ADDENDUM NO. 2
NEW GYMNASIUM FOR BARKLEY BRIDGE ELEMENTARY SCHOOL
Architect Job No. 24-107
April 23, 2025
DCM # 2025141

The Plans and Specifications are hereby amended. The following supersedes all contrary and/or conflicting information and is made part of the contract documents.

JOB NO. 24-107
SHEET NO: E1.1 1 OF 8
0 1" 2'

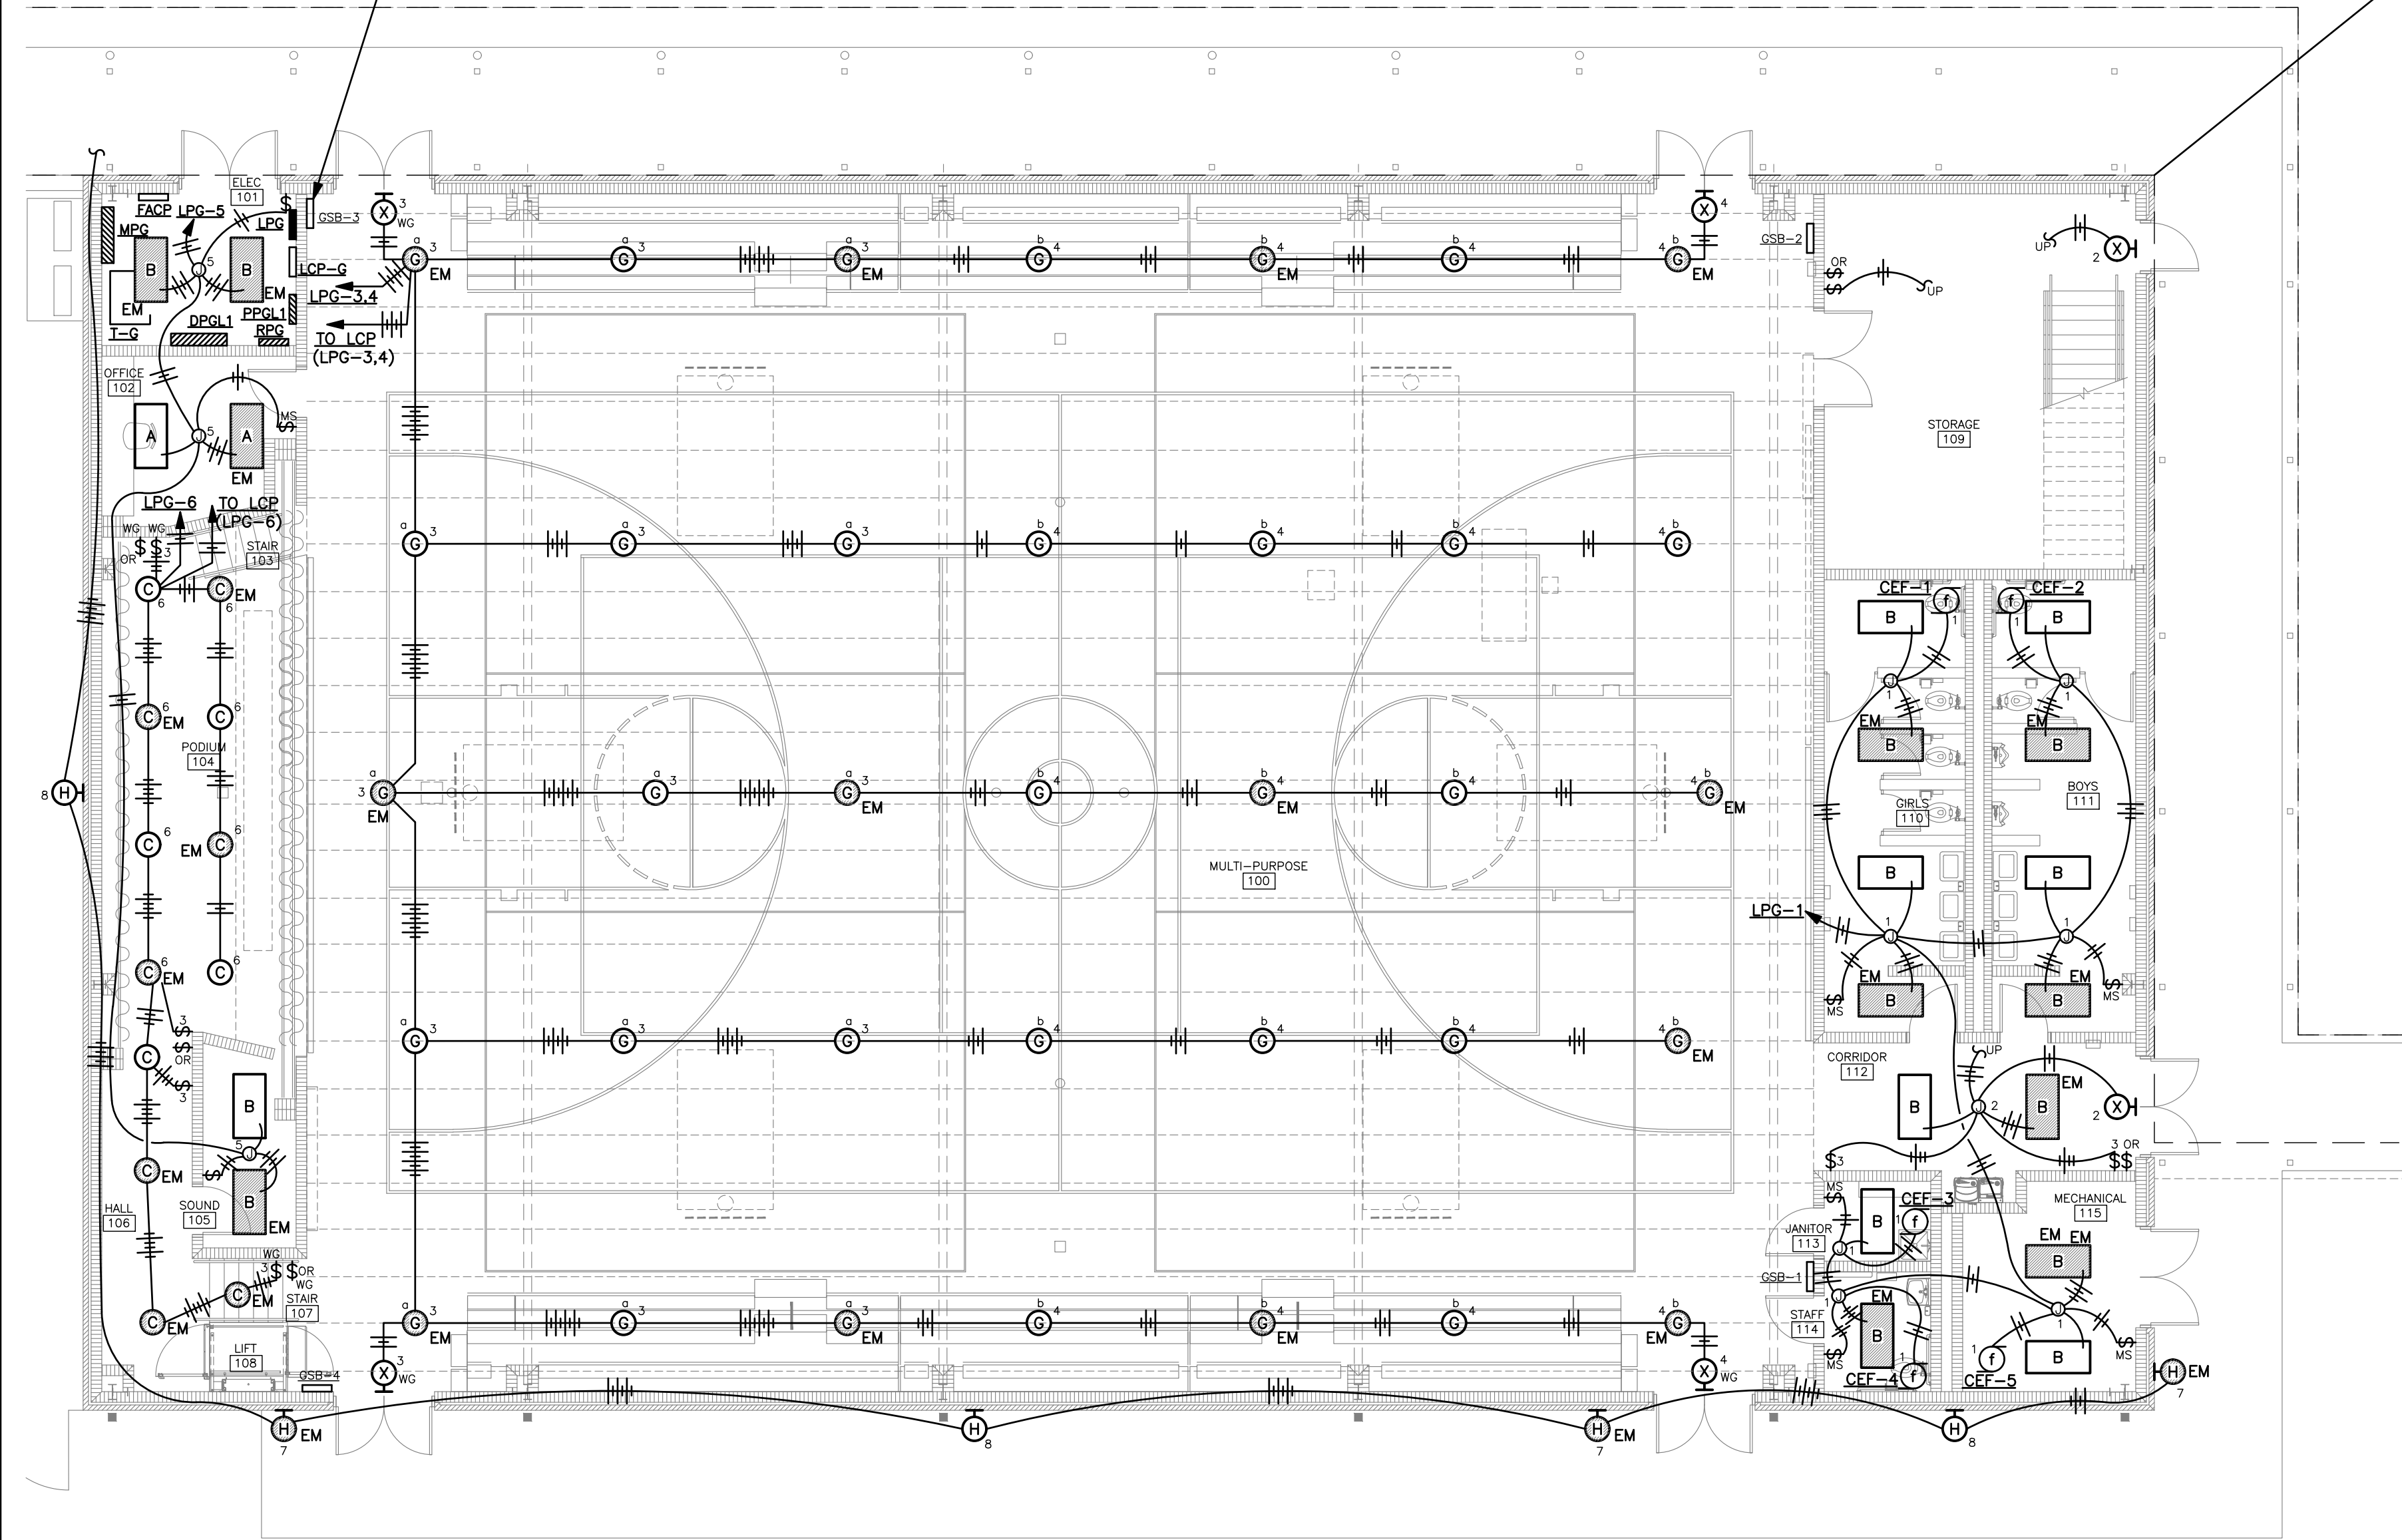
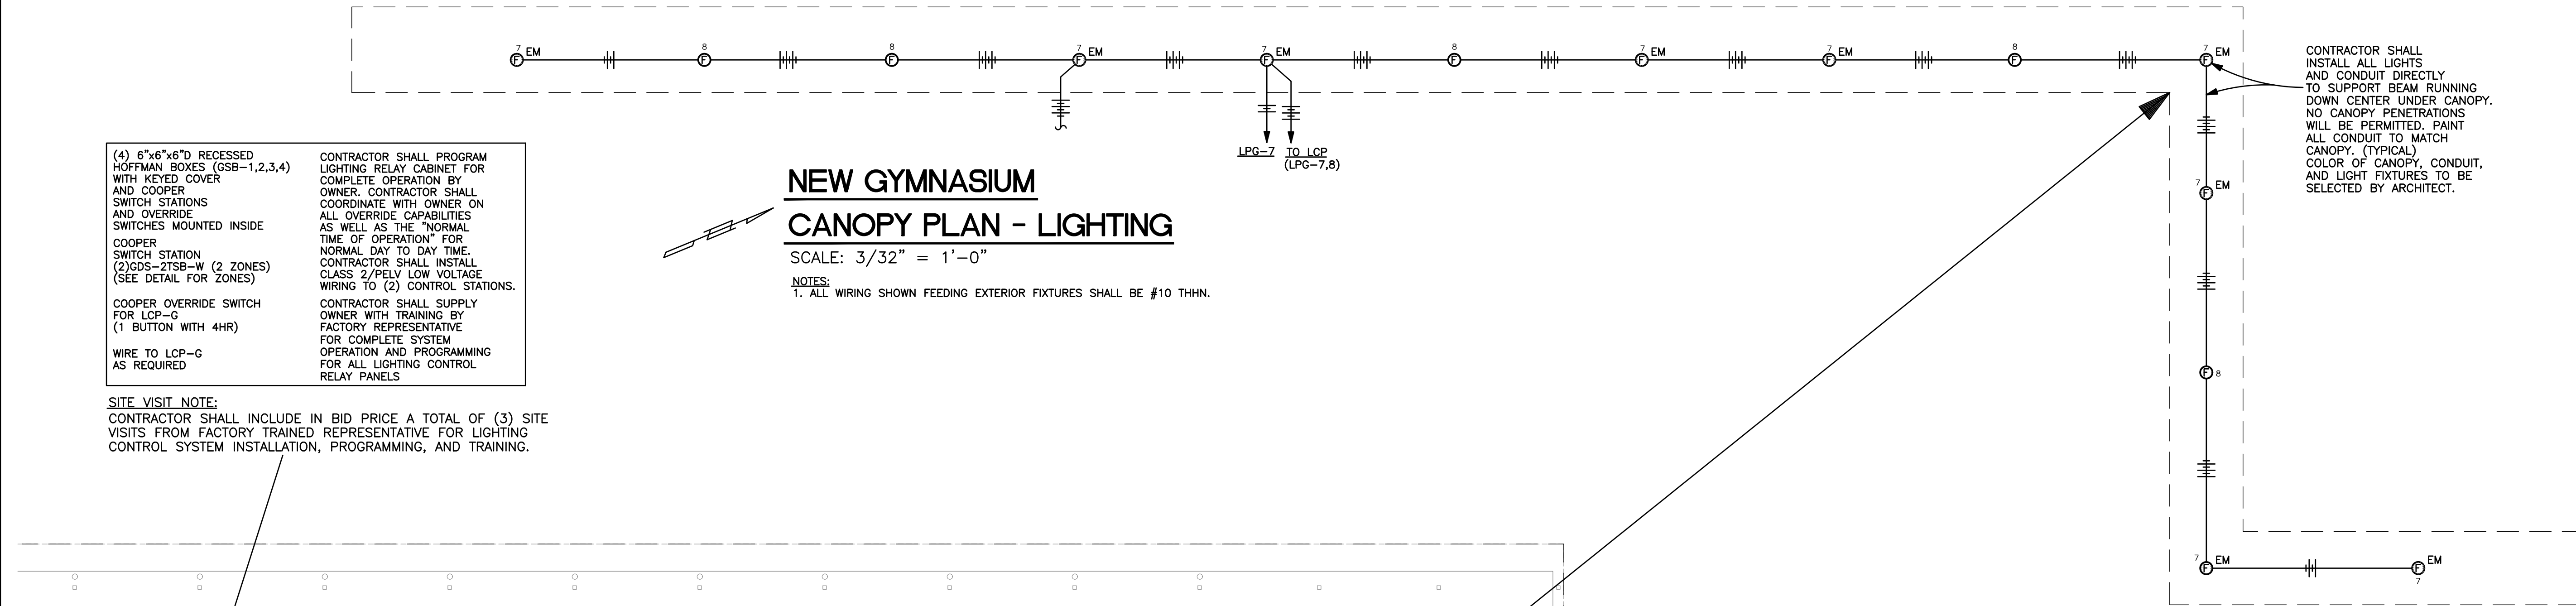
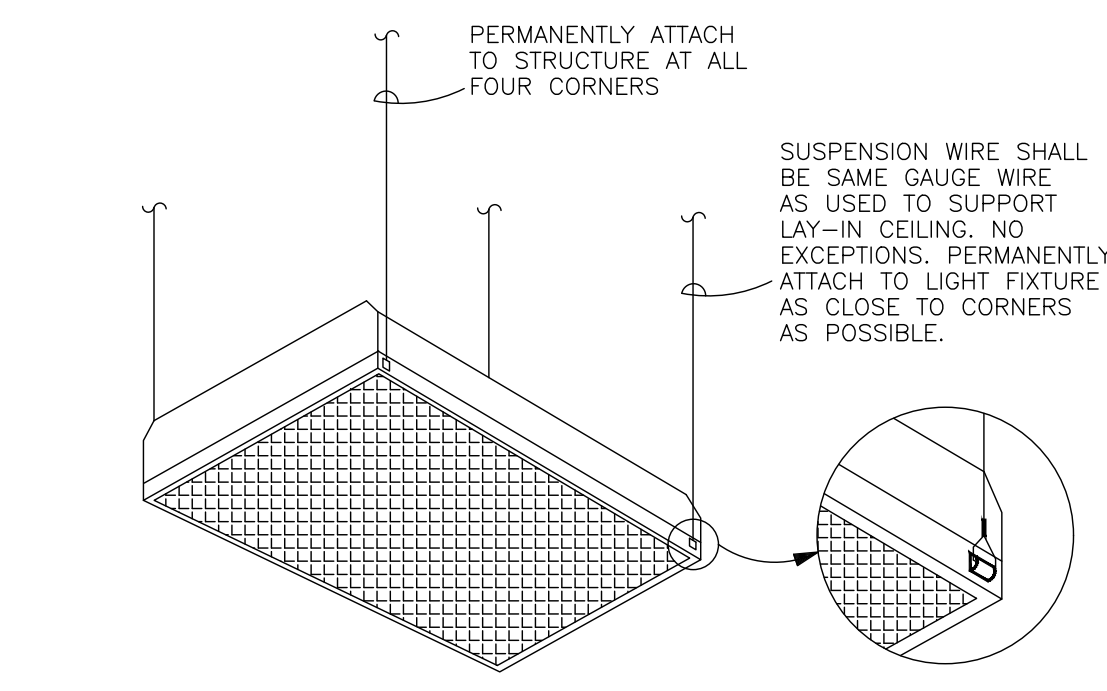
1. Sheet **E1.1** – Revised to include fixture types P1 and P2 from the Lighting Fixture Schedule. Revised to remove fixture types D and DEM from the Lighting Fixture Schedule.
2. Sheet **E3.1** – Revised to add circuits LPG-9,10 to Relay Panel LCP-G.
3. Sheet **E4.1** – Revised to show circuits to feed receptacle.
